Proposed s4.55(2) Modification Application for 318/2021/JP (PPSSCC-138)

40 Civic Way,
Rouse Hill NSW 2155

Applicant: Creative Planning Solutions Pty Ltd
on behalf of Link Wentworth

Extract of Proposed Basement Floor Plan

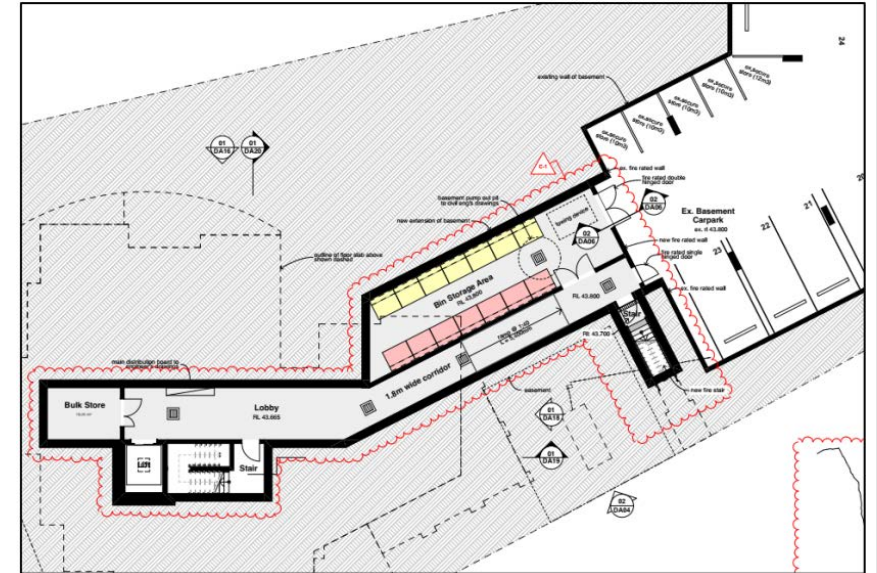
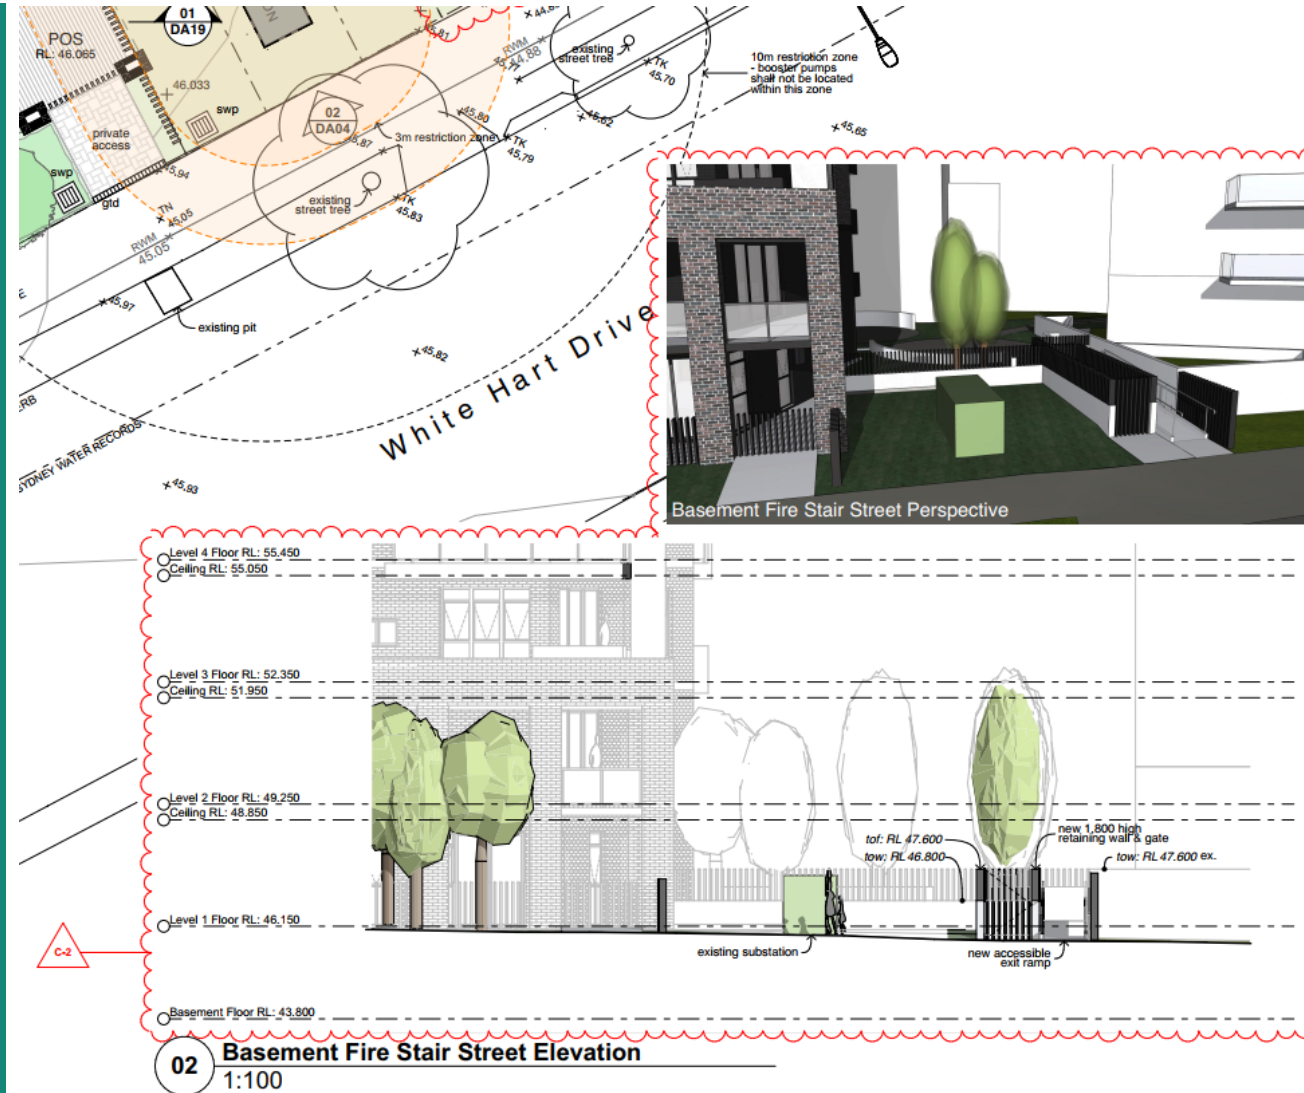
- BCA Report with DA had indicated that the buildings could be treated as separate buildings, with no fire safety upgrade required.
- Although ordinarily part of CC package, the proposal seeks to depict fire separation on the DA plans, showing self-closing fire-rated doors to replace the existing wall, as well as new fire stairs.
- Rearrangement of basement is largely associated with the above.
